TECHNICAL BULLETIN
LTB00842NAS2
19 FEB 2016

Heated Steering Wheel Inoperative

Range Rover Evoque (LV)
Model Year: 2012
VIN: 000447-704212
Assembly Plant: Halewood

E183709

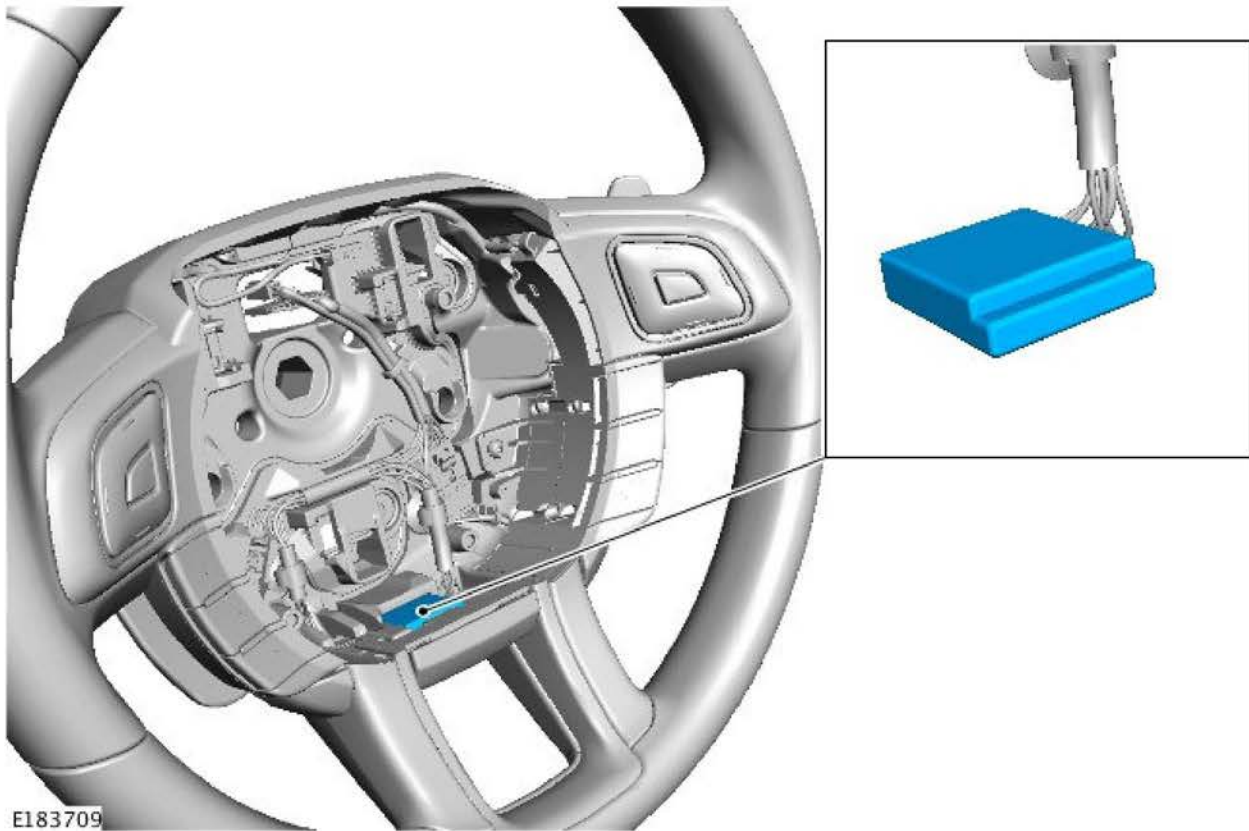
1. Steering Wheel Heater Control Module location.

E183710

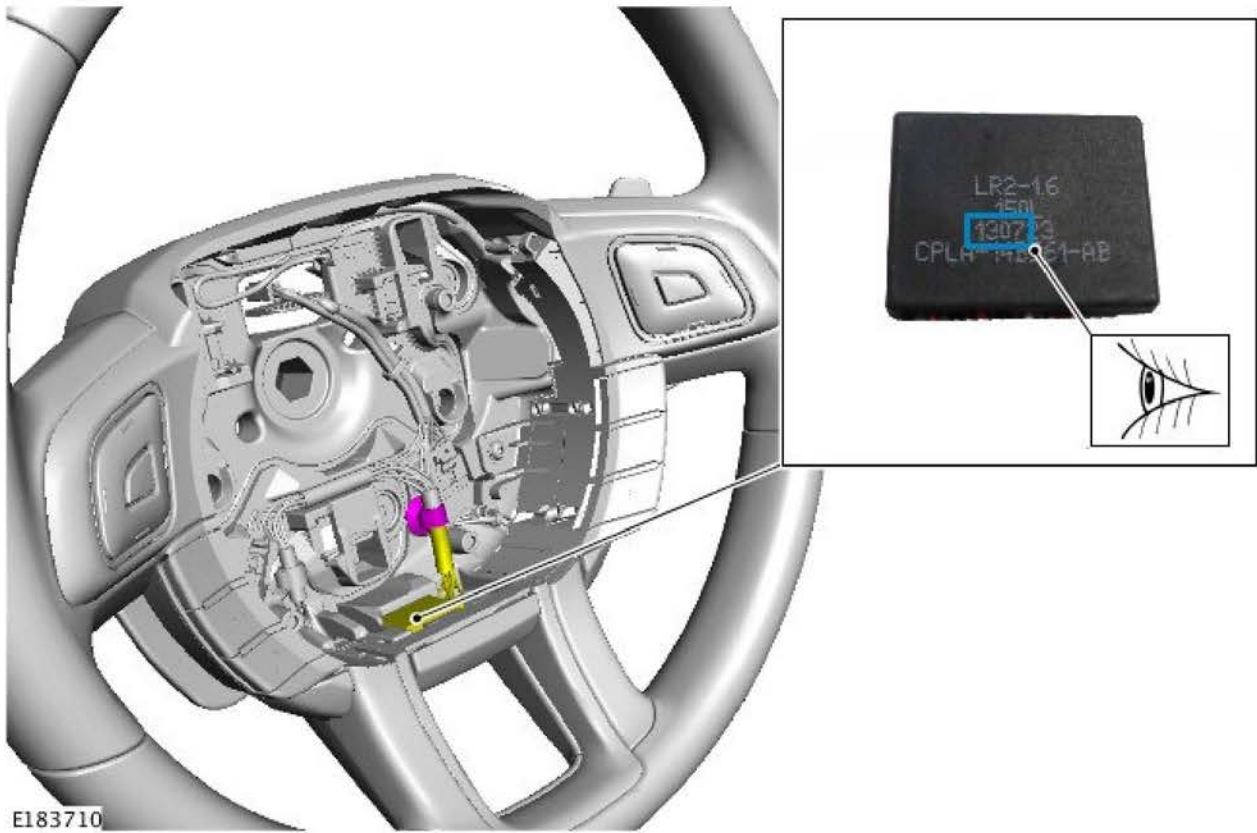
1. Remove the driver airbag module (see TOPIX Workshop Manual, section 501-20B: Supplemental Restraint System)
2. Position the Steering Wheel Heater Control Module to one side and check the manufacturing date as shown.
 - If the date is before 08/2012 (**1208**) then proceed to the next step.
 - If the date is 08/2012 (**1208**) or later, proceed with the diagnosis of the fault. To be carried out as a separate claim.

3. Replace the Steering Wheel Heater Control Module (see TOPIX Workshop Manual, section 211-04: Steering Wheel).
